RE: Wastewater Treatment Plant Improvements 2019  
City of Mount Vernon  
DNR Project No. 2017-0177A

Subject: Variance Request from 567 IAC 64.2(3)f and Design Standards Section 14.2.3.f

**MOUNT VERNON, IOWA  
WASTEWATER TREATMENT PLANT IMPROVEMENTS 2019  
WASTEWATER CONSTRUCTION PERMIT – VARIANCE REQUEST**

<b>IOWA DEPARTMENT OF NATURAL RESOURCES</b> ENVIRONMENTAL SERVICES DIVISION Field Office 1 909 West Main Suite 4, Manchester, Iowa 52057 Phone: (563) 927-2640 FAX: (563) 927-2075	
<b>REPORT OF INVESTIGATION</b>	
INVESTIGATION DATE	CURRENT: 04/15/19 LAST: N/A
TO: Larry Bryant, DNR Wastewater Section	
SUBJECT: Mount Vernon Wastewater Treatment Facility Expansion Site Survey NPDES # 57-58-0-01	
PERSONS CONTACTED: Emily Linebaugh – Veenstra & Kimm Alex Volkov – Mount Vernon WW Operator-in-charge	
<b>AUTHENTICATION</b>	
INSPECTOR: <i>Chris Gelner</i> Chris Gelner, Environmental Specialist	DATE: 4/17/19
REVIEWER: <i>Amber Sauser</i> Amber Sauser, Environmental Specialist Senior	DATE: 4/17/19

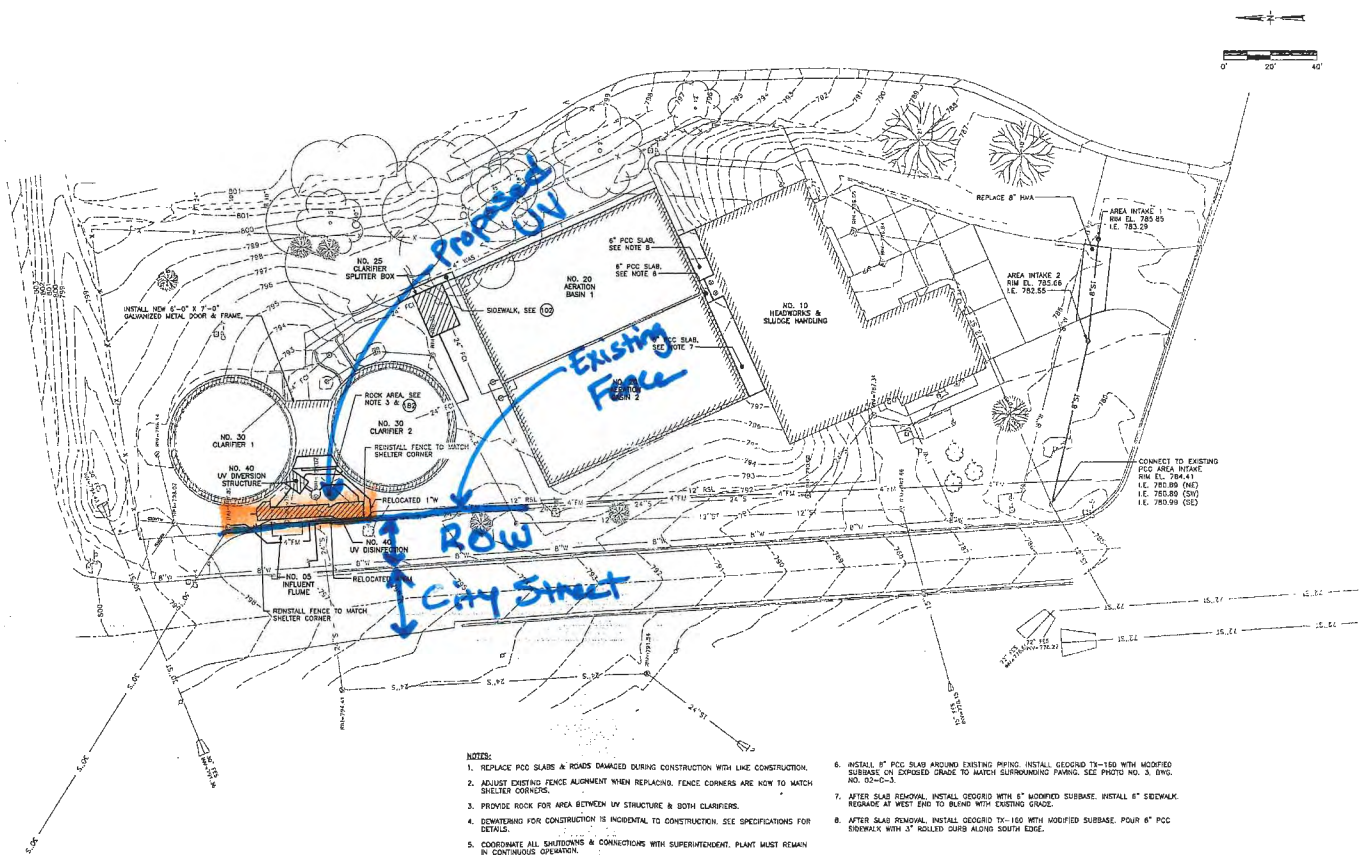
Currently the west side of the plant is approximately 12 ft from the west property line. The proposed expansion will put the UV structure approximately 3 ft from the west property line. This separation distance does not currently, nor will the expansion, meet the requirement of 25 ft to property line. It should be noted that the property line is between the City wastewater treatment facility and a City-owned roadway.

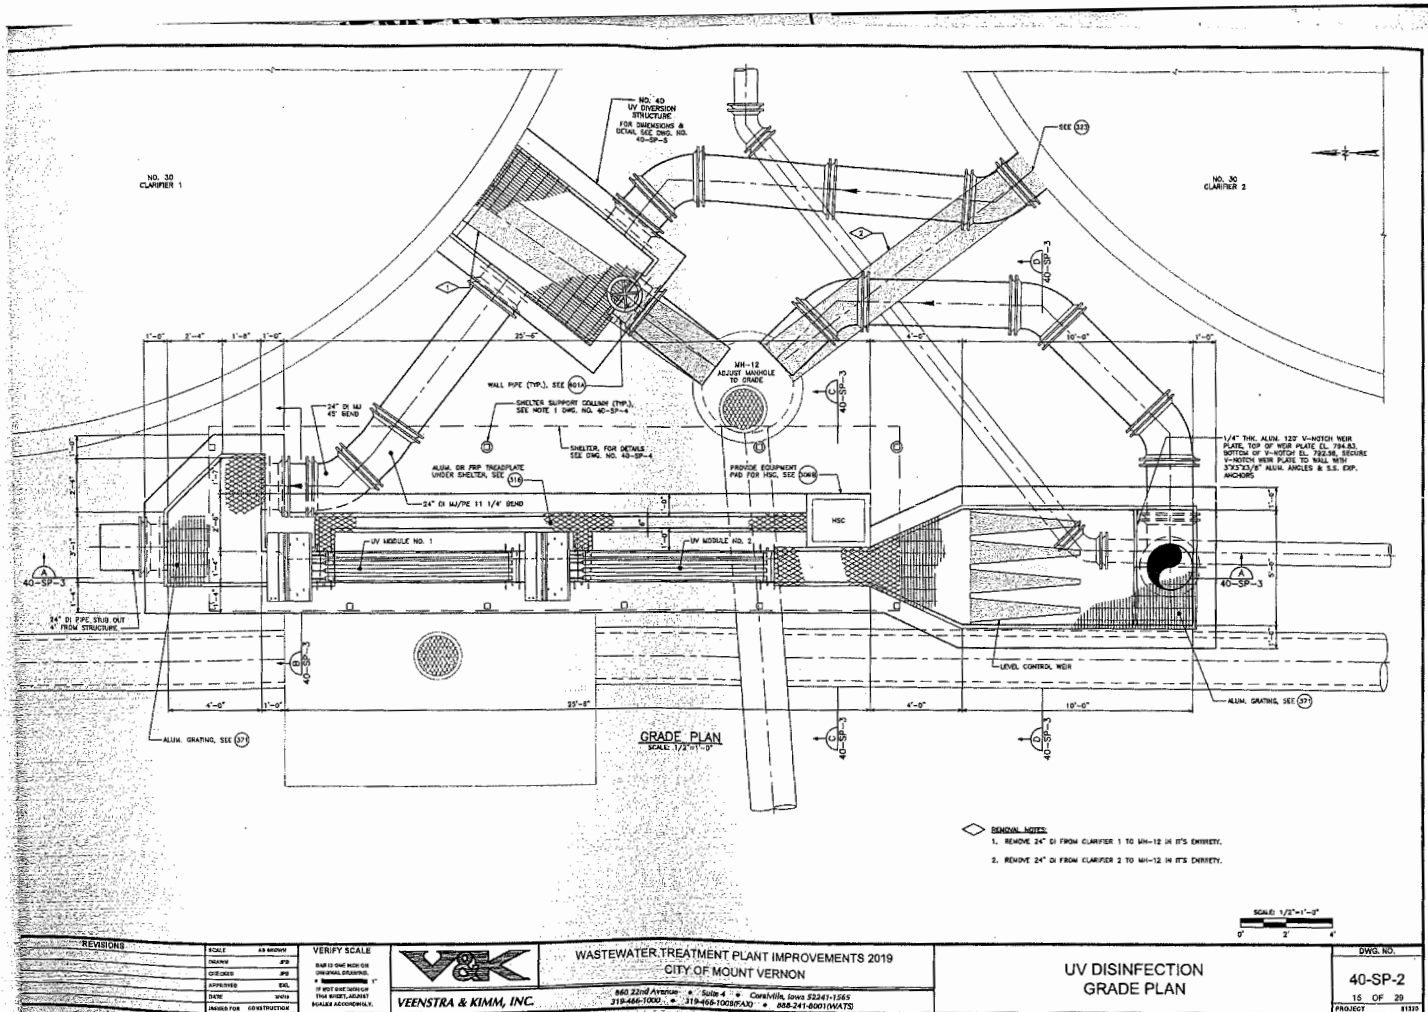
1. Name, address and telephone number of entity requesting the variance:
  - a. City of Mount Vernon  
Representative: Chris Nosbisch  
213 1<sup>st</sup> Street W  
Mount Vernon, Iowa 52314  
Ph: (319) 895-8742
2. Description and citation of specific rule from which a variance is requested:
  - a. A variance is requested from IAC 567 64.2(3)"f" and the Iowa Wastewater Facilities Design Standards Section 14.2.3.f which require a minimum separation distance from treatment water surfaces of 25 feet for property lines and rights-of-way. The construction of the UV channel and shelter is approximately 3' from the right-of-way line and approximately 22' from the edge of the City-owned street.

3. Specific variance requested, scope, and operative period for which the variance will extend:
  - a. The variance is requested to allow construction of the UV channel and shelter at less than 25' from the property line and right-of-way.

After careful and thorough consideration, the Department has **approved** your 4/18/19 request for a variance from Iowa Administrative Code Subrule 567 IAC 64.2(3)f and Chapter 14 of the Iowa Wastewater Facilities Design Standards, which requires a minimum separation distance of 25 feet from treatment surfaces to property lines and rights-of-way, or that the new separation distance be maintained at no less than 90% of existing.
